To: Planning Board
From: CDD Staff
Date: August 3, 2018
Re: **Zoning Petition on Converting Flat Concave Roofs**

Subject: Rainwater Separation from Flat Roofs Zoning Petition

To: Planning Board
From: Jeff Roberts, Land Use and Zoning Planner
Date: May 17, 2016
Re: **Rainwater Separation from Flat Roofs Zoning Petition**

Date:	September 3, 2013
Subject:	Craig Kelley Petition (Flat Roofs / Rainwater Separation)
Recommendation:	The Planning Board DOES NOT RECOMMEND adoption of the proposed zoning amendment, but suggests alternative approaches.

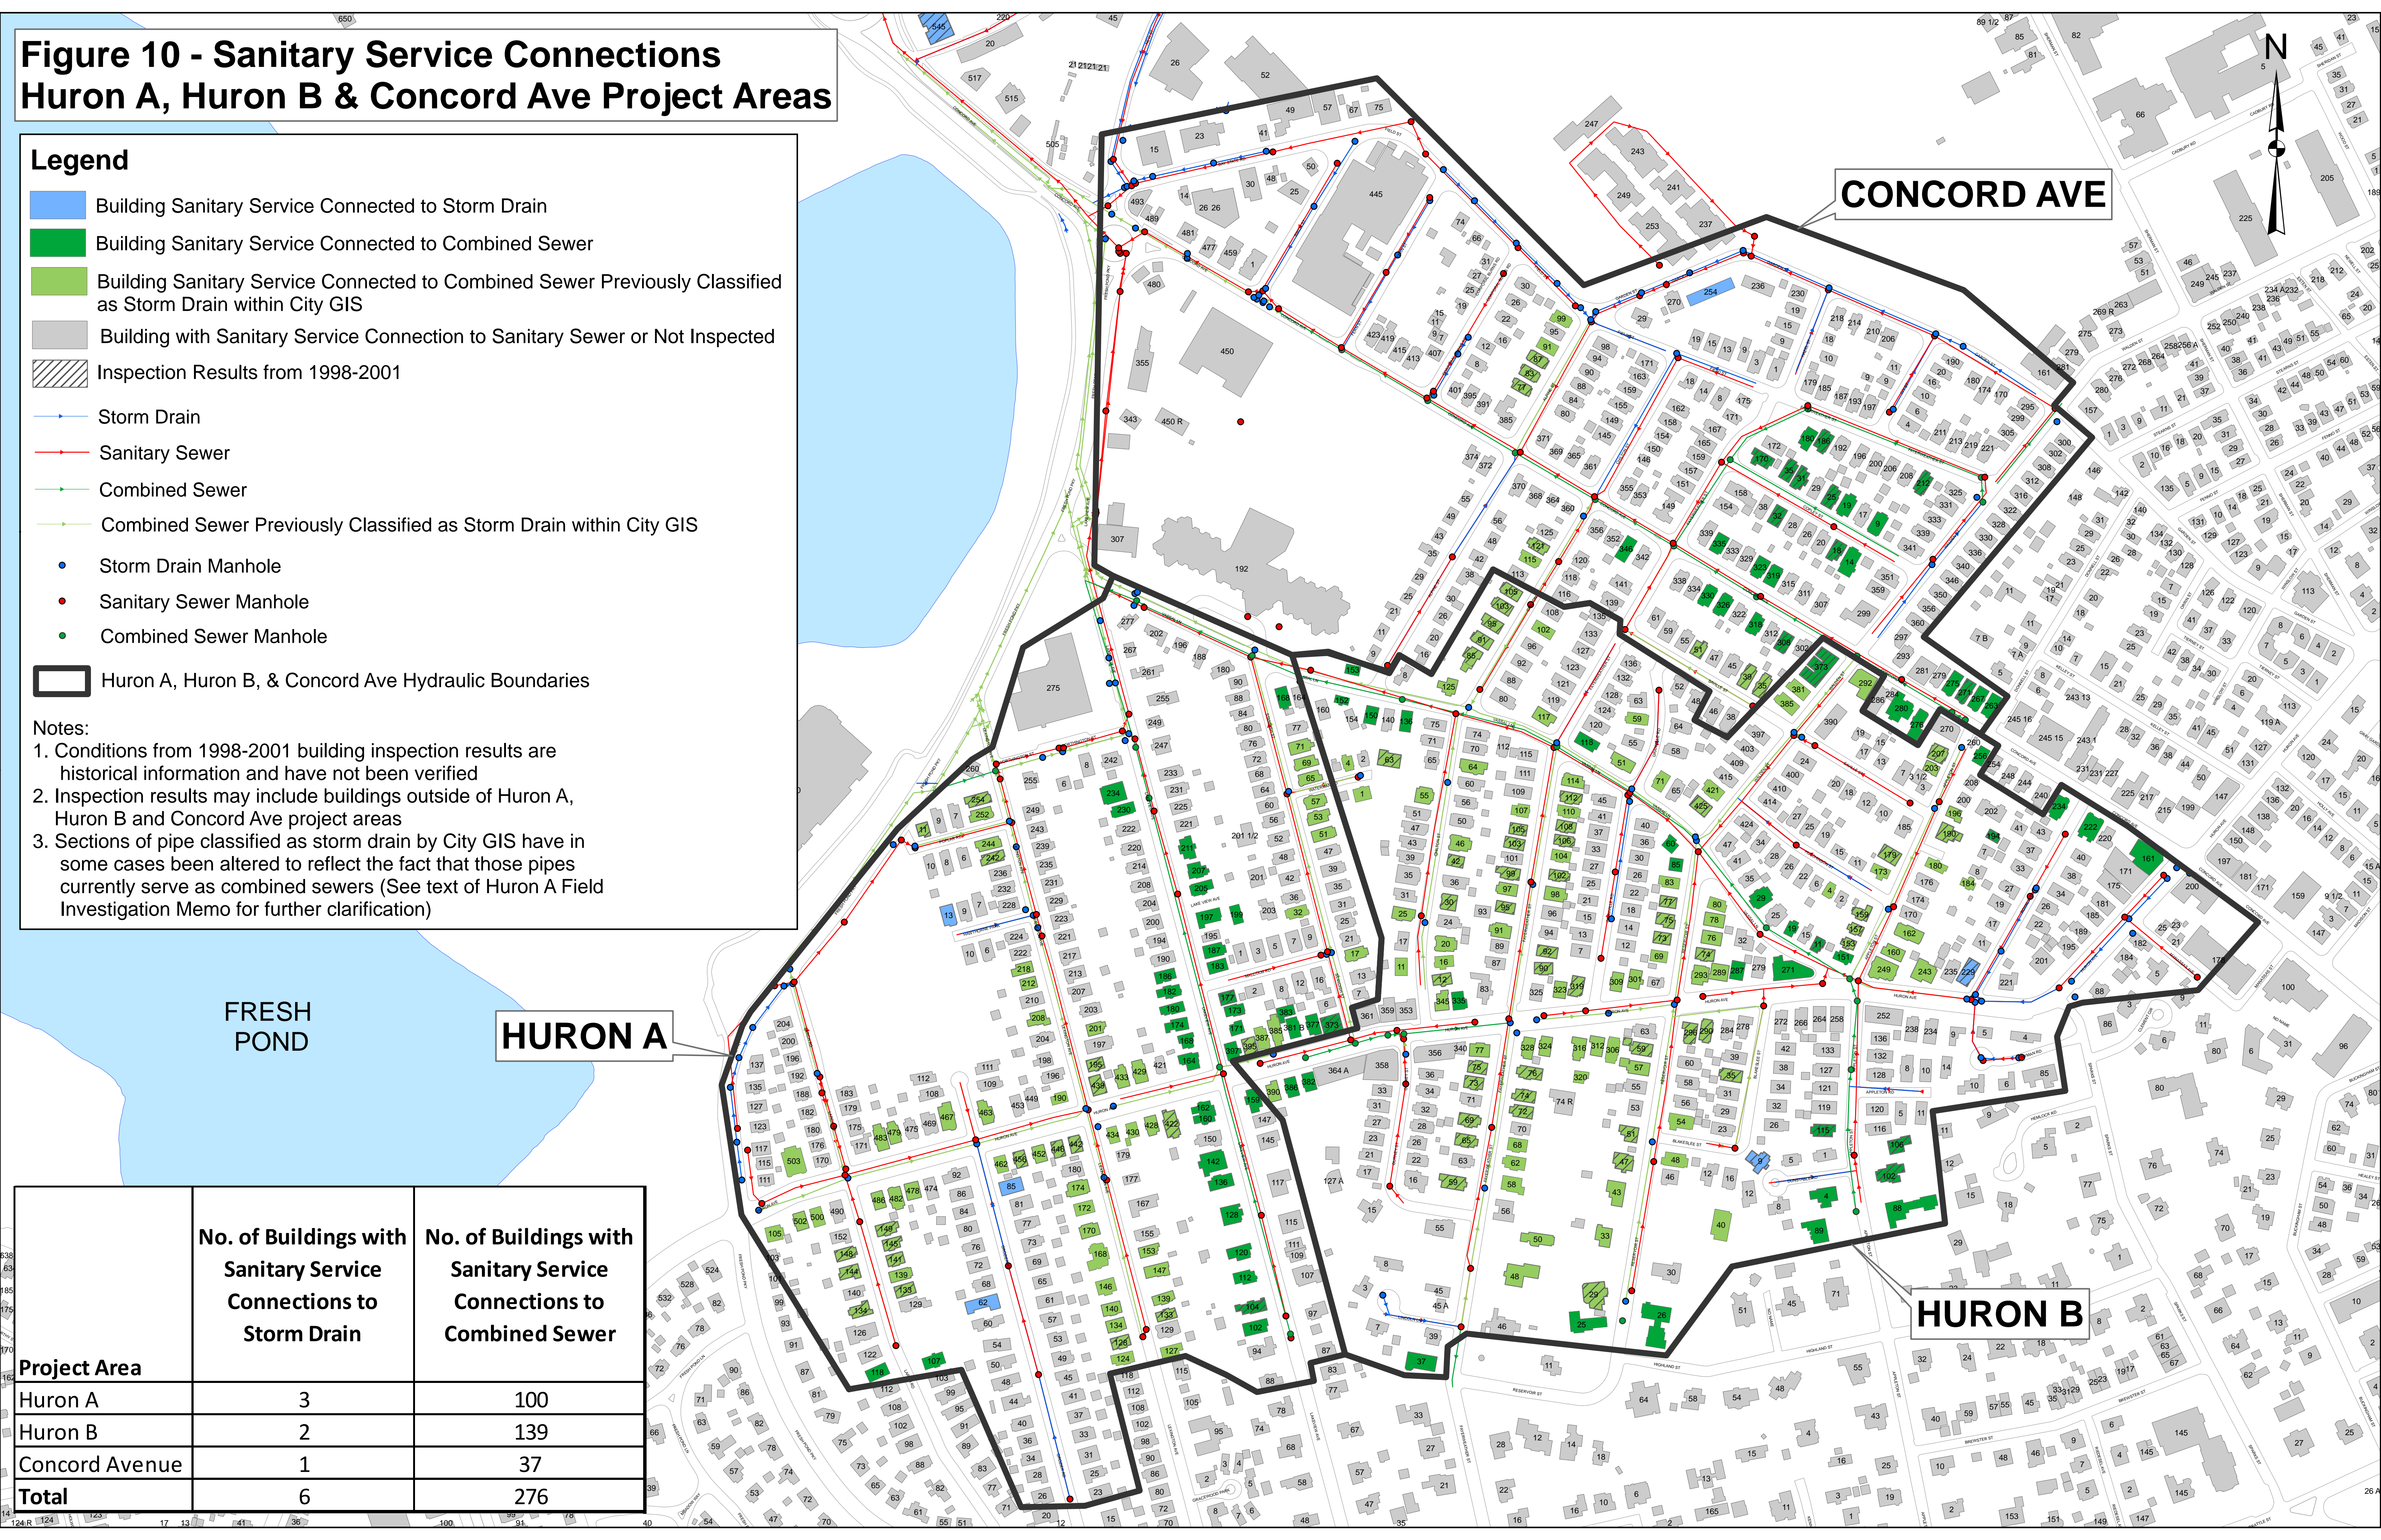
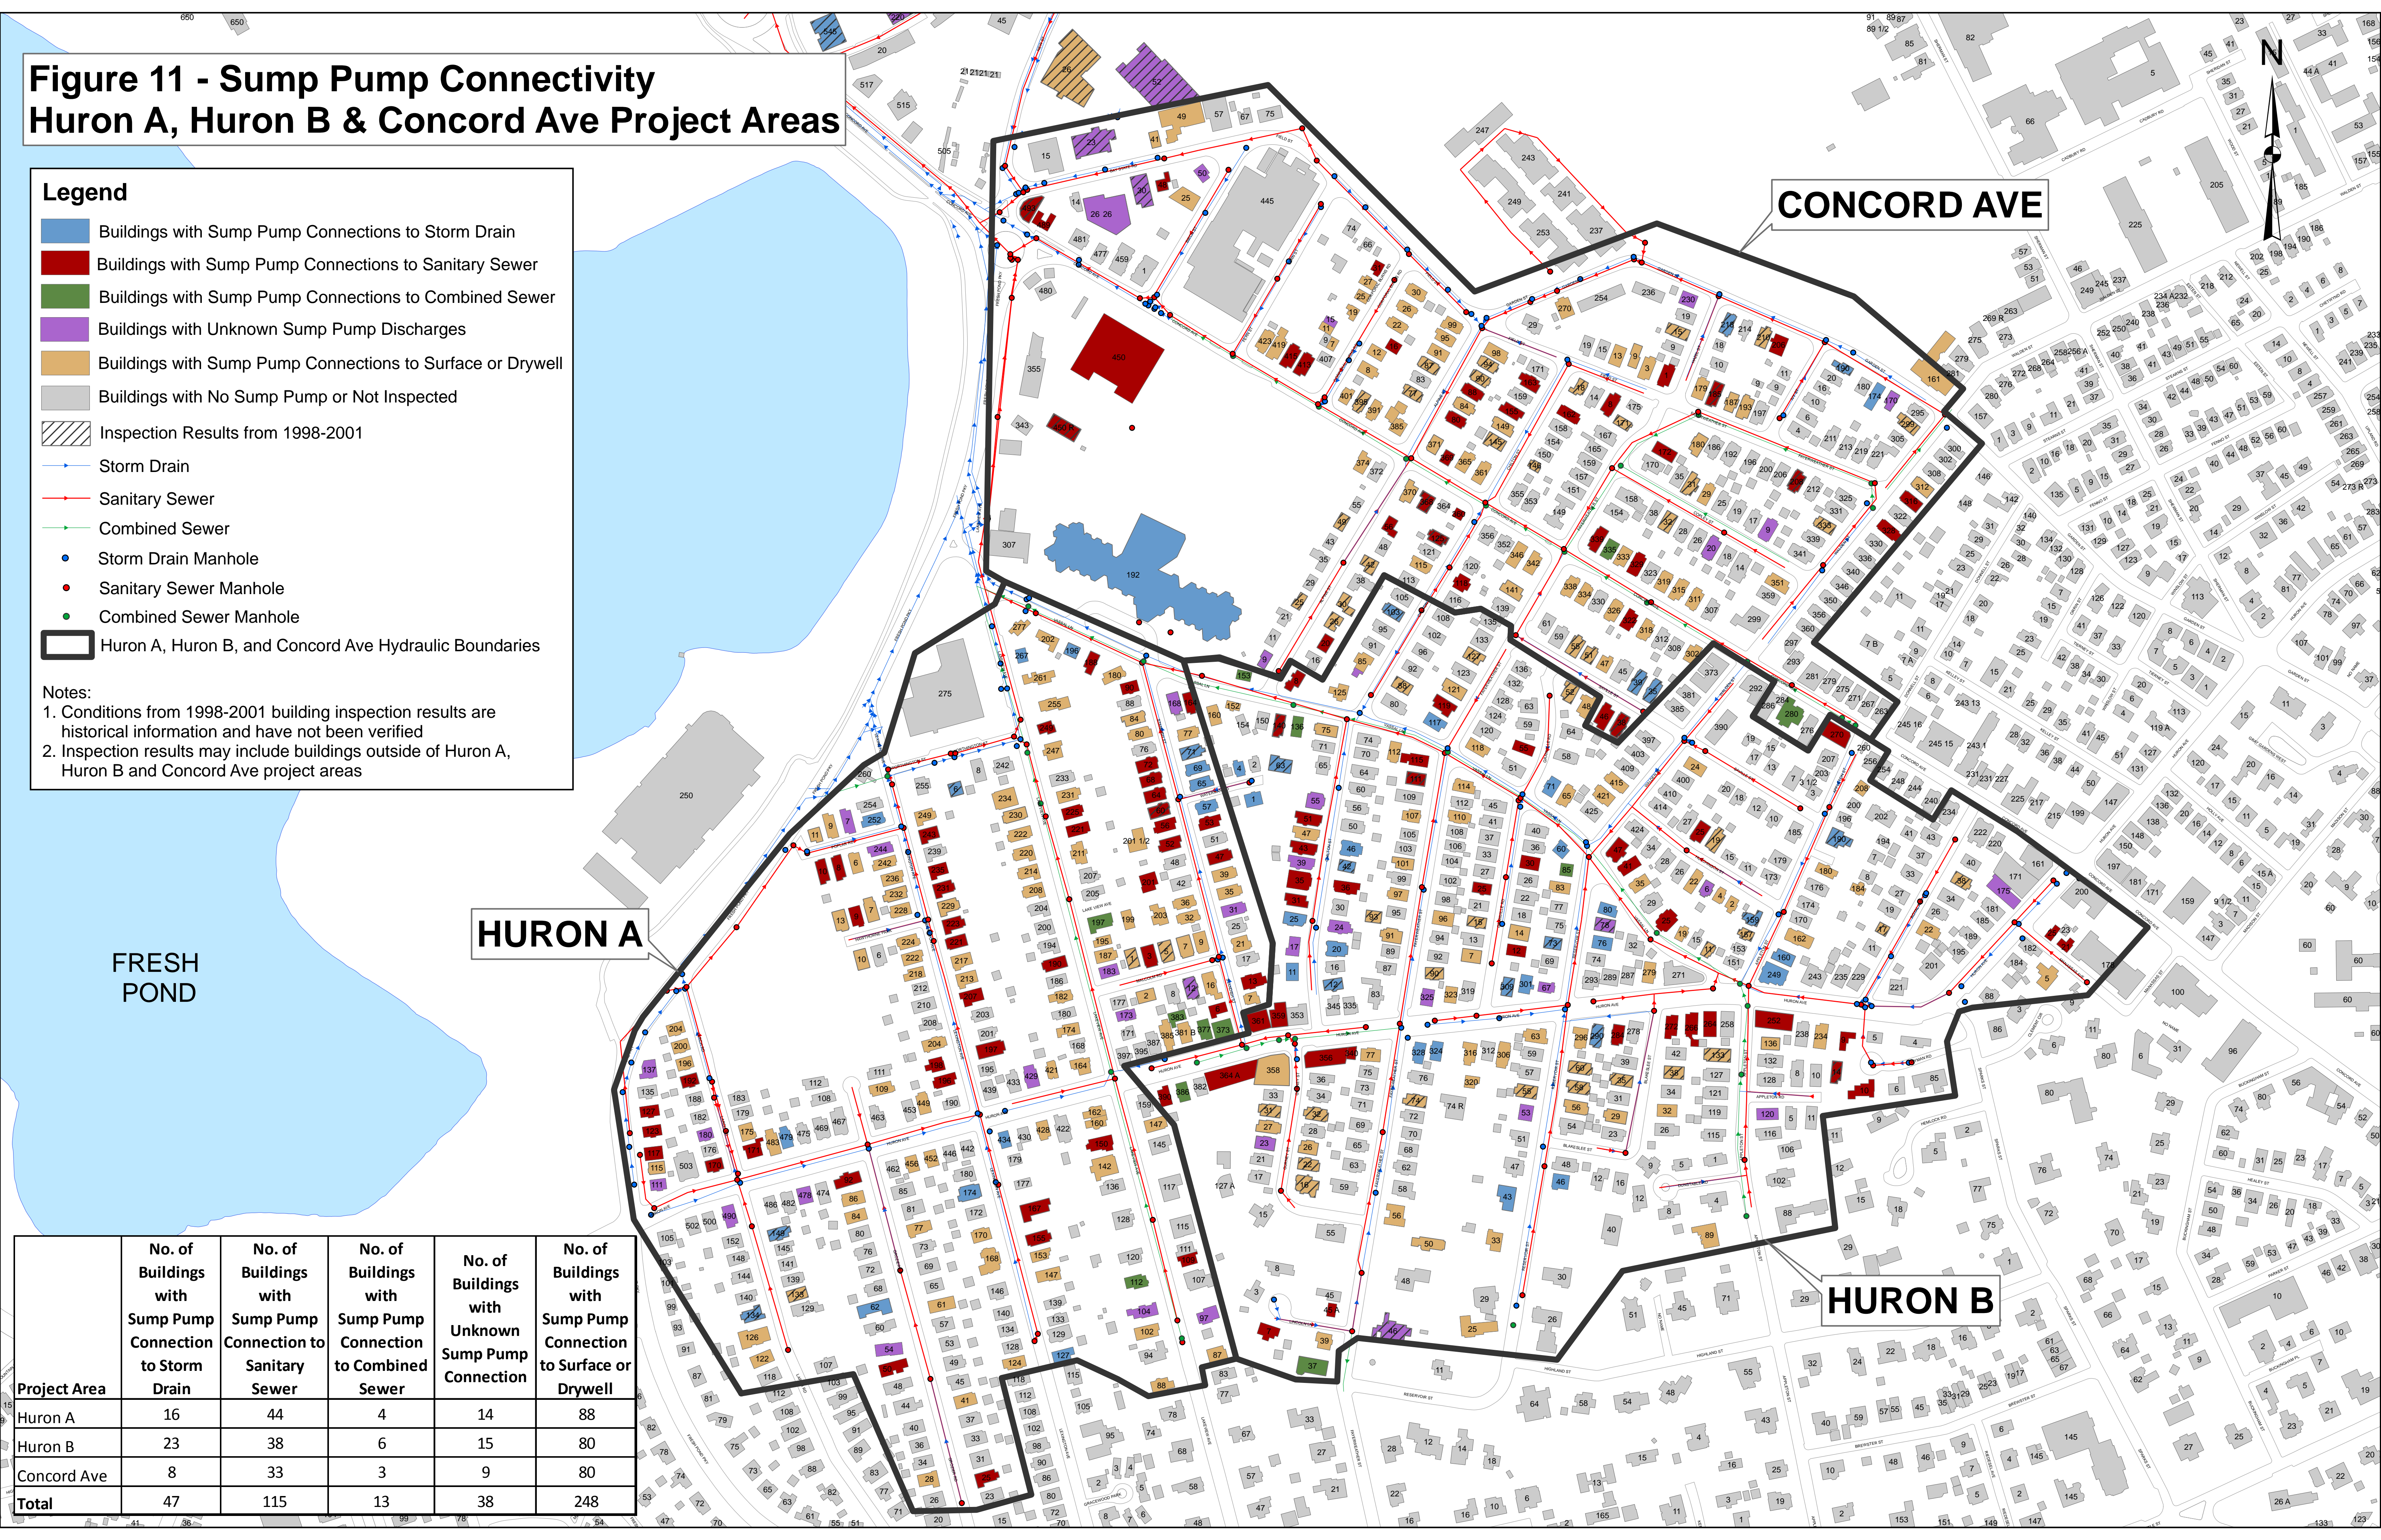
The attached maps illustrate the extent of the investigations completed by DPW as part of this effort. We have identified sixty seven (67) flat roof buildings within the overall area. Of those buildings forty eight (48) have two internal pipe systems, one for sanitary waste and one for rainfall conveyance. Of the forty eight buildings identified with two pipe systems, thirty one (31) have been selected for inflow removal. Of the nineteen (19) buildings with a single stack conveying stormwater and sanitary waste in one pipe down through the building, none of these have been selected for sewer separation. These buildings were not selected due to the significant work required to either internally separate these pipes or reconstruct the pitch of the roofs.
